Roads and Assets Referral Response

Application Number:	DA2021/2639
Date:	24/06/2022

Date:	24/06/2022
То:	Olivia Ramage
• ` ` '	Lot 52 DP 7593 , 25 Alleyne Avenue NORTH NARRABEEN NSW 2101

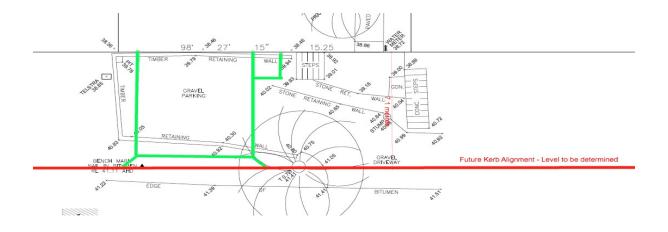
The design plan dated 22/5/2022 also does not comply with low level skew profile levels and the use of such a profile on the current alignment of the unauthorised parking area is not supported. A driveway crossing perpendicular to the carriageway is required in compliance with Council's standards.

The existing road surface levels may be lower than that required in the future. If road levels are raised, to be consistent with the existing longitudinal grade of the road, the driveway (which are at maximum grades) and car port levels will be impacted.

The construction of kerb and gutter across the frontage to connect to the existing k&g would be supported and would aid stormwater drainage.

Driveway access from the carriageway should be at 90 degrees to the carriageway to improve safe access, although noting this may result in lifting the car port floor level.

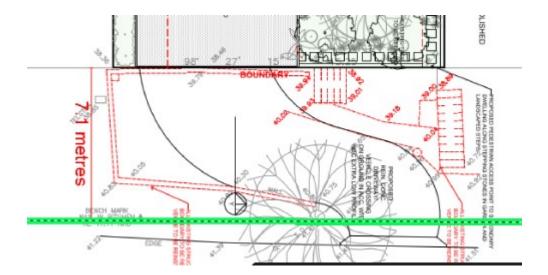
Amended plans dated 14/6/2022 DA-503 Rev B appear satisfactory on conceptual basis. Road Act Application will be needed for civil works on road reserve. Condition to be added by Development Engineering Team to resolve geometric and structural details and scope of works on road reserve including any retaining walls, widening of driveway crossing to improve access etc once DA plans meet Development Engineering Teams requirements.

The proposal is therefore supported.
